Subject: Arkansas Nuclear One - Unit 2
Docket No. 50-368
License No. NPF-6
Response to First Request for Additional Information from the NRC Reactor
Systems Branch Regarding the ANO-2 Power Uprate License Application

**Request for Additional Information
from Reactor Systems Branch Personnel Regarding the
Arkansas Nuclear One, Unit 2 (ANO-2) Power Uprate License Application**

SAR FIGURE NO. 4.I-1

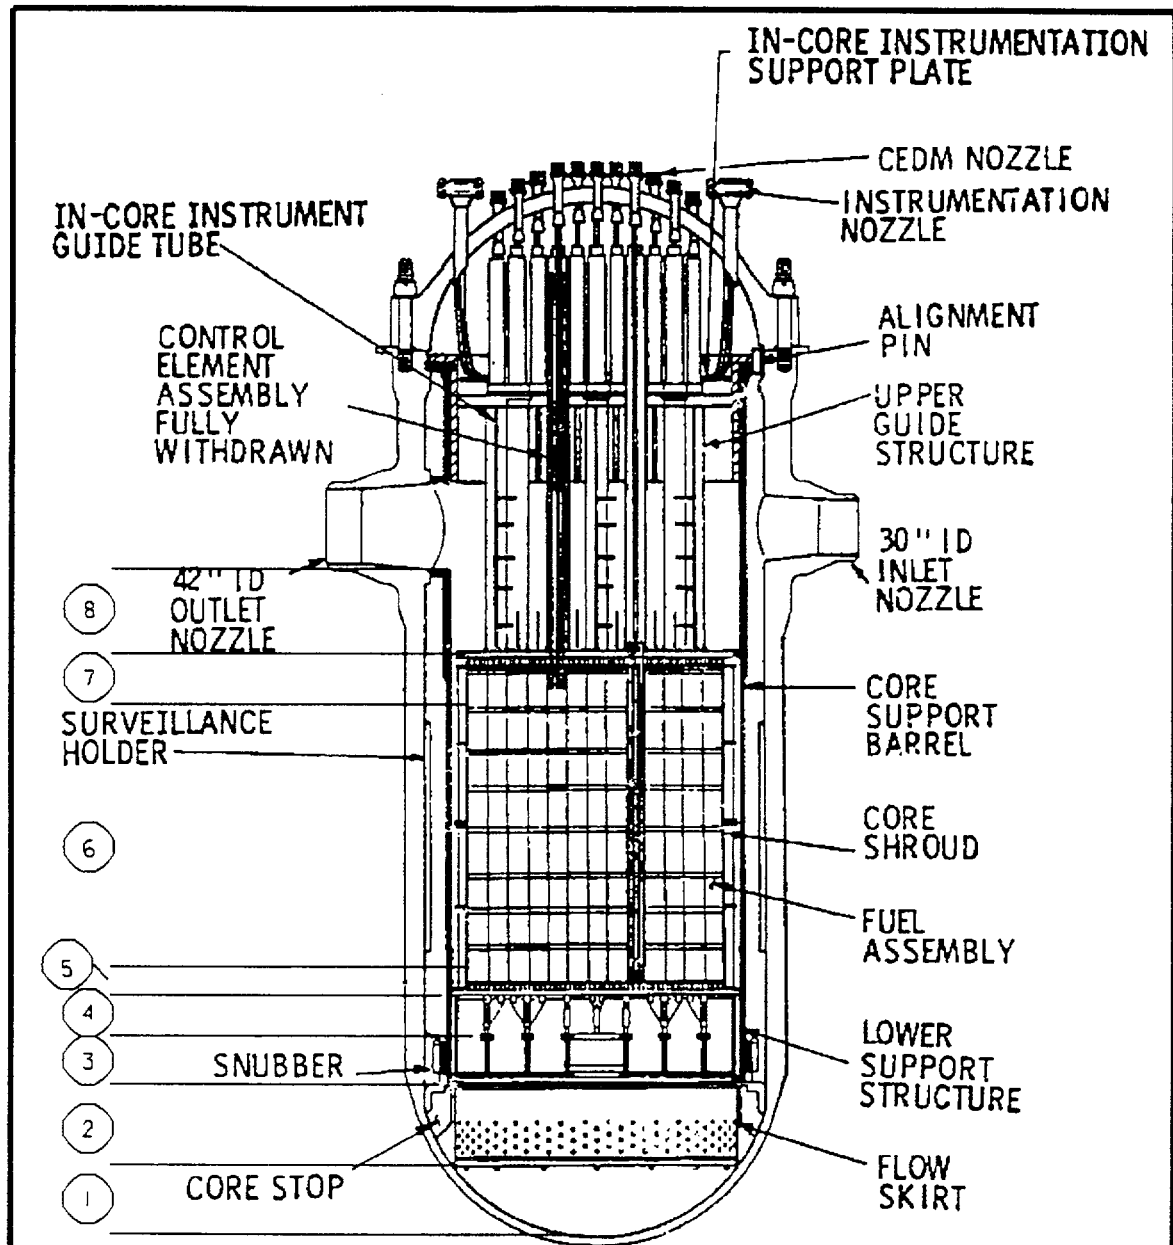
Page 7-6 of the PULR states that the long-term cooling model is different than the one referenced in the ANO-2 SAR. Please provide your long term cooling analysis as required by the Safety Evaluation approving topical report CENPD-254-P-A when it is first applied to a plant application referencing the report.

During the September 27, 2001, conference call, the staff requested the value of the mixing volume used in the ANO-2 power uprate boric acid precipitation analysis, as well as various ANO-2 reactor vessel water volumes. A value of 10,532 gallons (1408 ft³) was calculated for the ANO-2 mixing volume. As a discretionary conservatism (i.e., a conservatism not required by the methodology), the input value used in the BORON code was reduced to 10,000 gallons (approximately a 5% reduction). Table 1 lists water volumes for the lower plenum, core, and outlet plenum regions of the ANO-2 reactor vessel. From the information presented in Table 1 on the following page, the total water volume that is inside the core support barrel (excluding the water between the core support barrel and the core shroud) and between the top of the core support structure and the bottom of the core barrel outlet nozzles (i.e., Regions 5 through 8), is 968.1 ft³.

1. See ANO-2 SAR Figure 4.1-1 (next page) that has been annotated with circles drawn around numbers 1-8 to depict the top and bottom elevations of Regions 1 through 8.
